NABCO ENTRANCES TECHNICAL BULLETIN

New Power Supply For GT1175

Bulletin Number: **70**

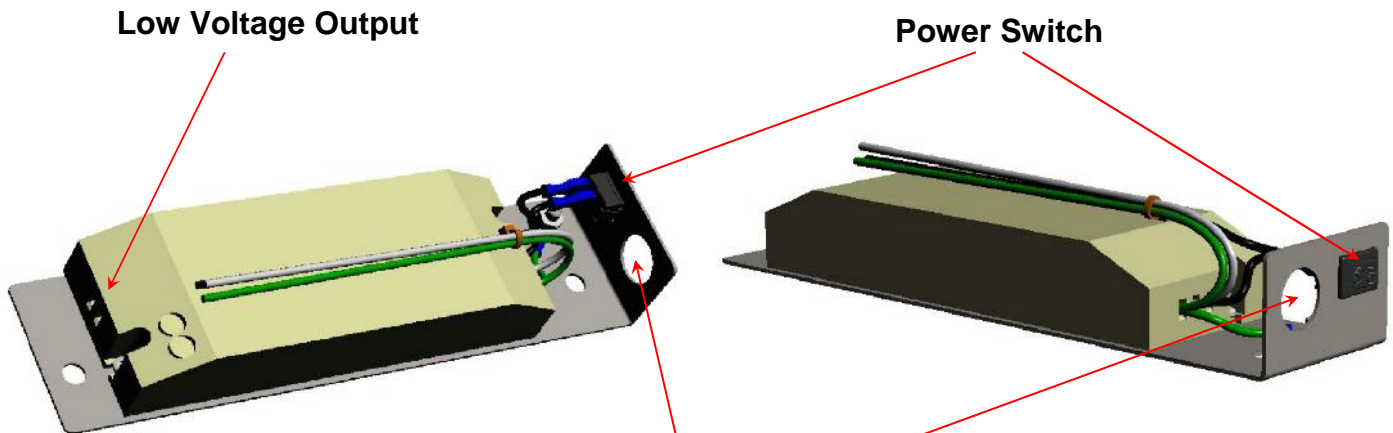
GT1175 sliding doors will now come equipped with a new “switching” power supply.

- Lower profile
- Built in short circuit protection
- Greater efficiency
- Can accept input voltages from 100 to 240 VAC

Old Power Supply P.N. A-00029
(14-11741)

Incoming power will now be connected using pigtail wires from the power supply assembly rather than a terminal strip, otherwise there is no change to the installation/service process. 1175 manuals will be updated to show this soon.

New power supply Part Number: A-00717

Do not run loose wire through this hole.
This 7/8" hole is intended for securing
conduit or for use of cable clamps.
